AMENDED OFFICER RECOMMENDATION

ITEM NUMBER: DIS101
ITEM TITLE: RECOMMEND ADOPTION OF LOCAL STRUCTURE PLAN NO.16 – LOT 9041 WILLYUNG ROAD AND LOTS 44 & 46 BILABOYA PLACE, WILLYUNG.

ATTACHMENT : REVISED STRUCTURE PLAN SHOWING MARKED UP RECOMMENDED MODIFICATIONS

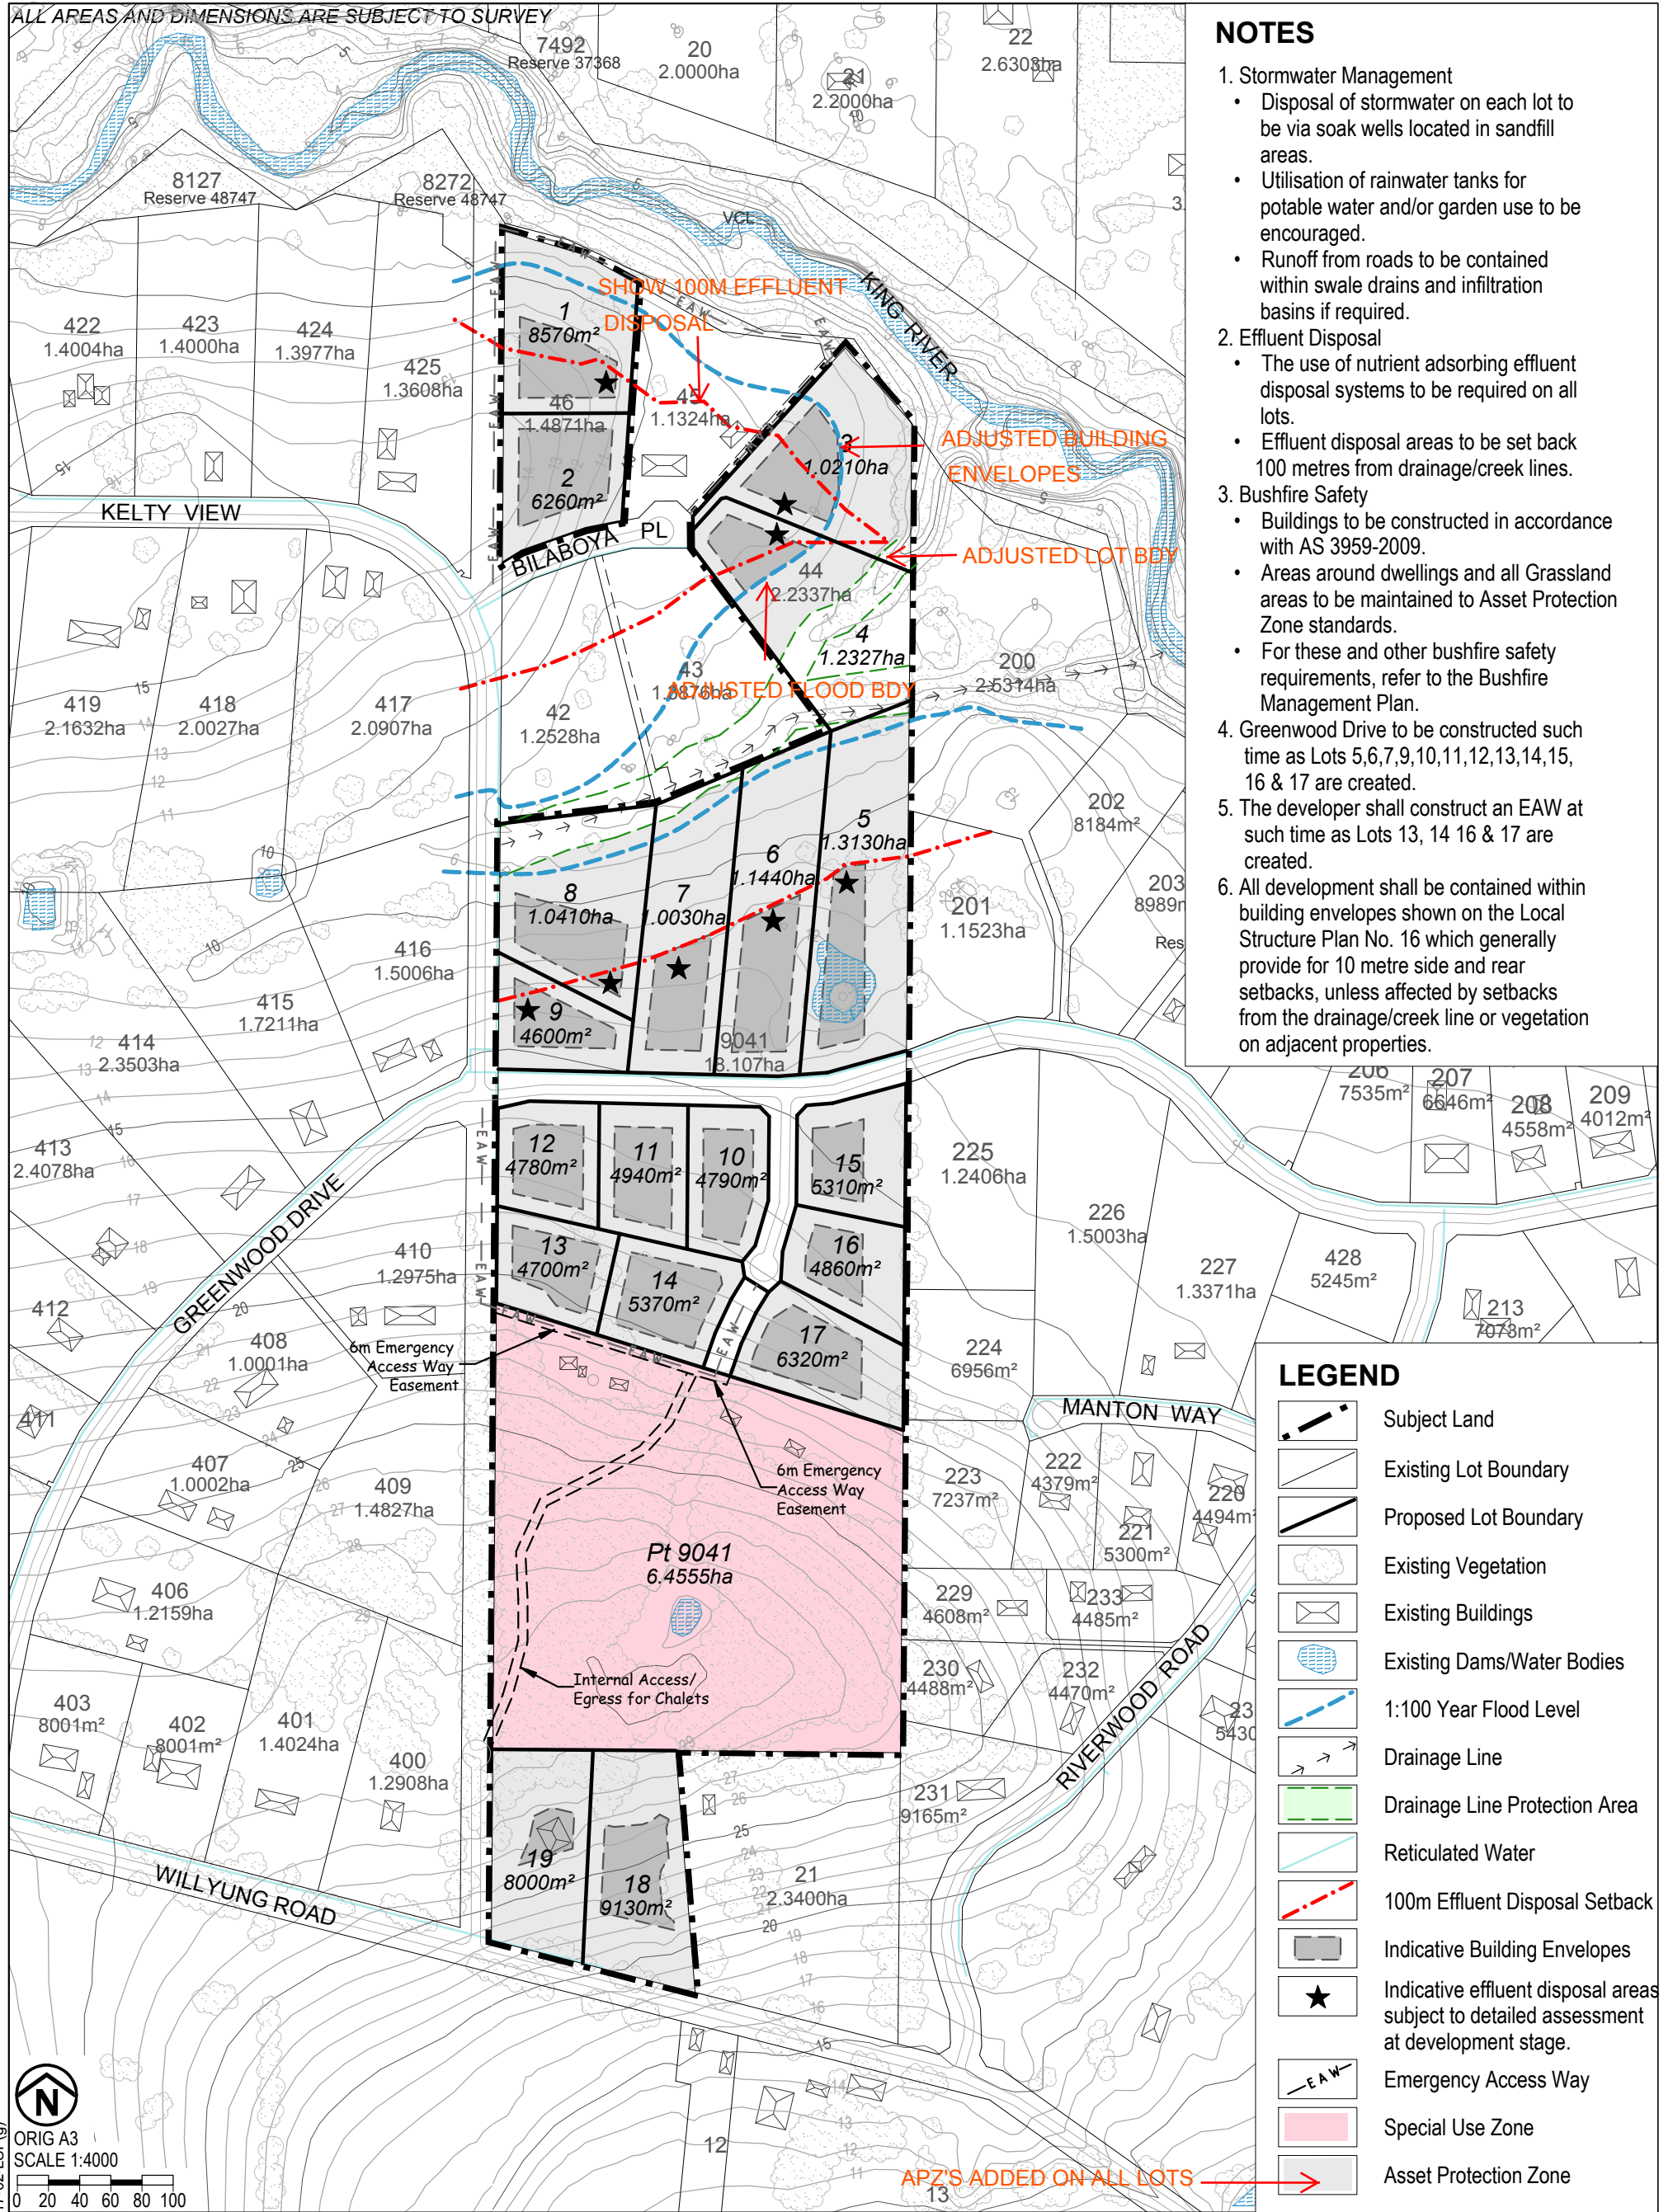
- **Adjust the flood boundary in the northern section of the structure plan to reflect data recorded in the land capability assessment completed for the structure plan;**

- **Adjust Lot 3 & 4 lot boundaries and building envelopes to accommodate for modified flood boundary;**
 - **Delete portion of the 'Drainage Line Protection Area' to reflect land characteristics;**
 - **Include a '100m Effluent Disposal Setback' boundary to reflect land characteristics.**
2. **Forward structure plan documentation and submissions to the Western Australian Planning Commission with a request that the Commission grant approval to the structure plan (with modifications).**
 3. **Advise the applicant/owner and those who lodged a submission of the Council decision accordingly.**

On closer inspection of flood data, it has been revealed that the flood boundary on the map does not match the land capability assessment data (Table 6 p 29).

Table 6 shows that the predicted flood level for proposed lot 4 is 8.5m. It appears that the flood boundary on the map is not drawn on the 8.5m contour.

An area is incorrectly shown as a 'Drainage Line Protection Area'. This land does not represent a creek. Portion of the land has been filled. The creek running west-east does not link to the northern section.

A recommended modified indicative layout for lots 3 and 4 that is consistent with the correct information is detailed below.

APZ'S ADDED ON ALL LOTS
